UNITED STATES PATENT AND TRADEMARK OFFICE

APPLICATION NO.	FILING DATE	FIRST NAMED INVENTOR	ATTORNEY DOCKET NO.	CONFIRMATION NO.
10/041,833	10/19/2001	David Laverne Sprinkle	DEE6270P0160US	5412

# Office Action Summary

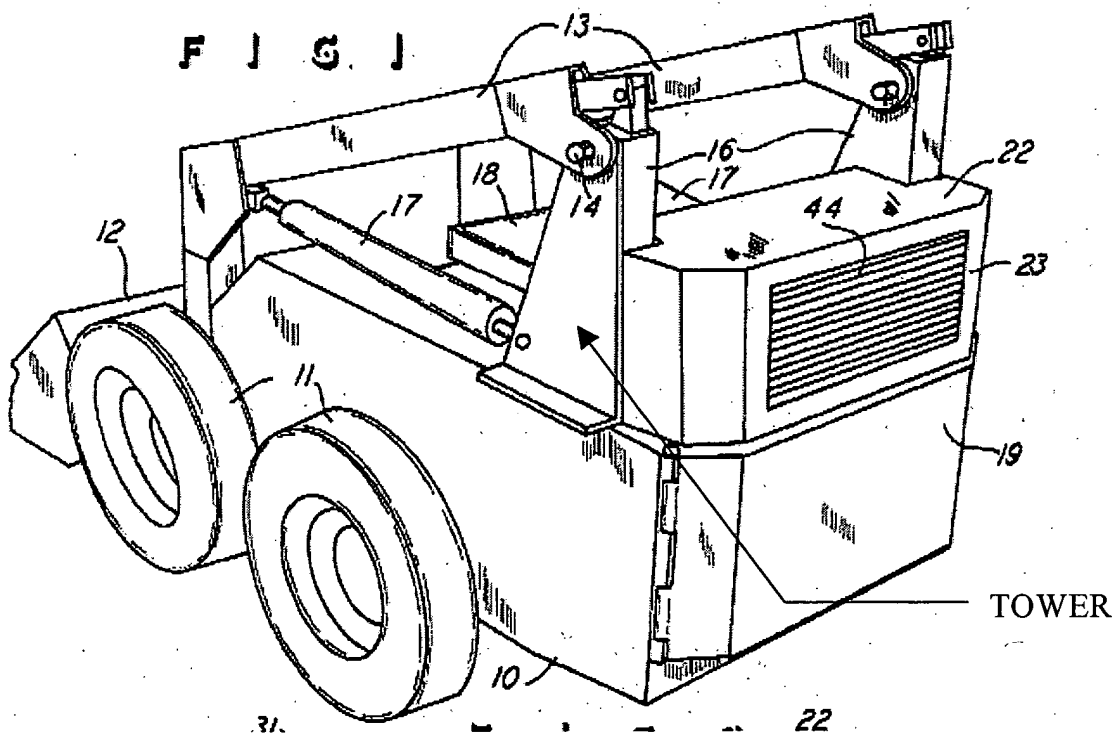
a pair of towers (see sketch on next page) supported on said chassis and extending substantially vertically (Figure 1);

a pair of boom arms (13) pivotally connected (14) at base ends thereof to a top of each tower, respectively and connected at distal ends thereof to said loader bucket (see sketch next page); and

paths from closer together at tops of said towers to further apart at bottoms of said towers (see following comment).

Regarding the last lines of claim 1; note on the following sketch that a substantially vertical load path exists between the top and the bottom of the towers. Note also that the very base of the towers has a wider portion. Note that in this wider portion at the base that the vertical load path that this “portion” of the load path will be displaced laterally and further apart, since there is a wider cross-section of the tower in which the load is distributed.
